Chen Harvey

Response to Mercer Island comments letter

ARBORIST TREE PLAN

ARBORISTS SITE PLAN

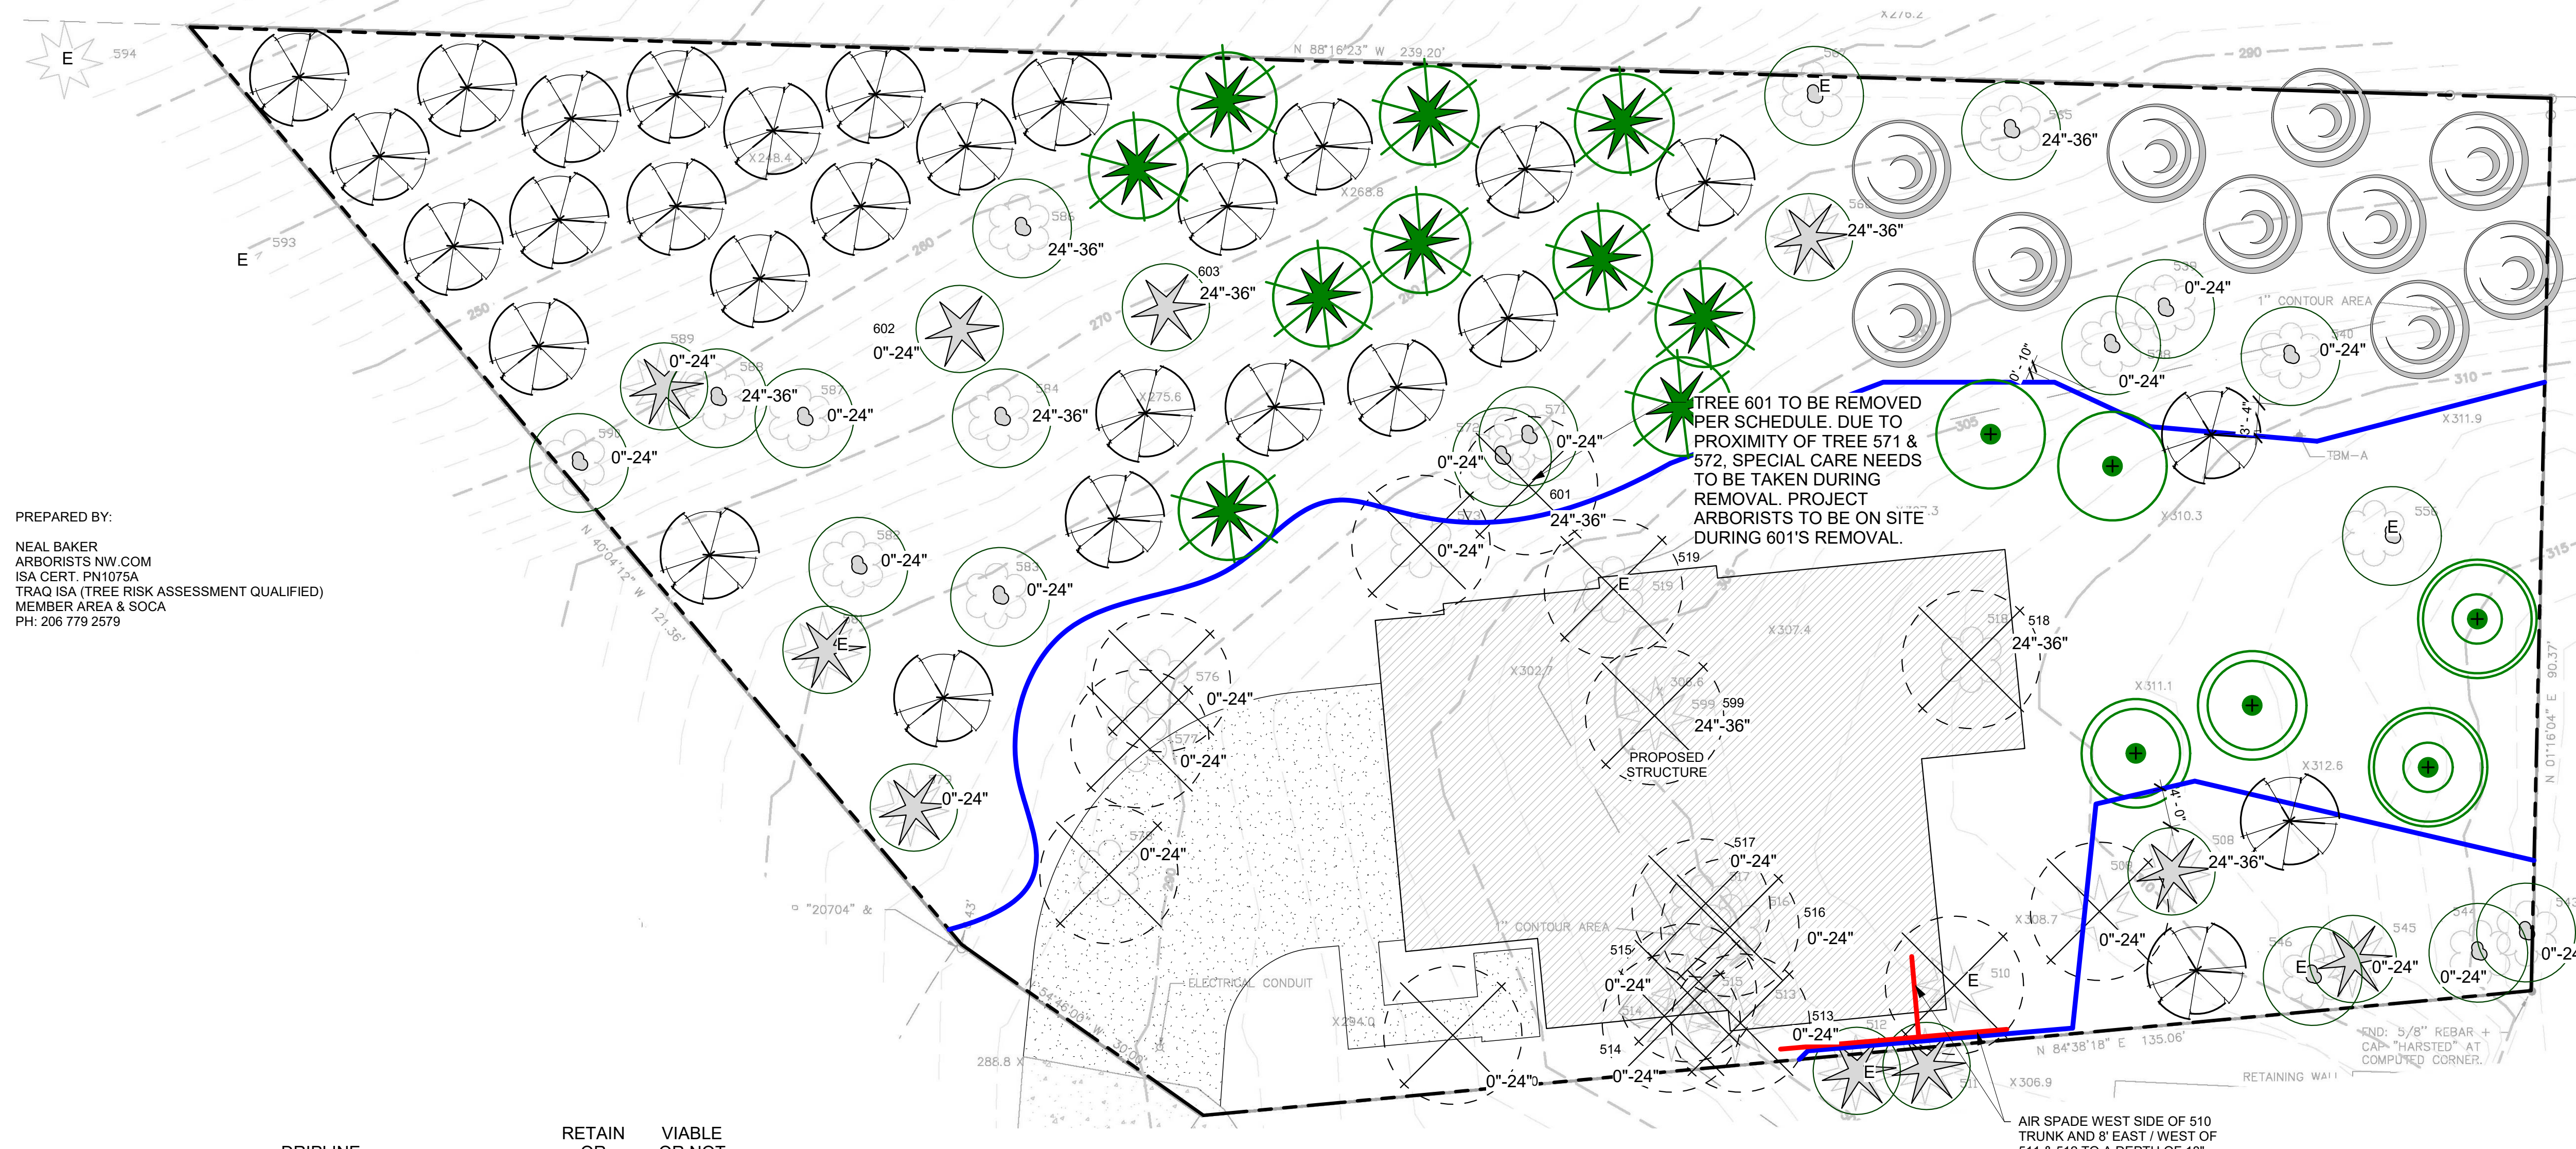
The tree protection fencing has been adjusted out to 40' for tree 508. The dripline is artificially wider than normal due to damaged treetop. Tree 579 has had its dripline rescaled to the correct size

Replanting plan: has been updated to include 55 trees.

Regarding the determination of critical root zones: The tree protection fencing is located outside of the driplines of all retained trees and is mapped as such. Given as there are large swaths of trees on the West and north side of the proposed construction individual limits of disturbance are not included and would be redundant. Again, Limits of Disturbance on trees directly adjacent construction are located outside their driplines, this covers any tree behind those adjacent as well.
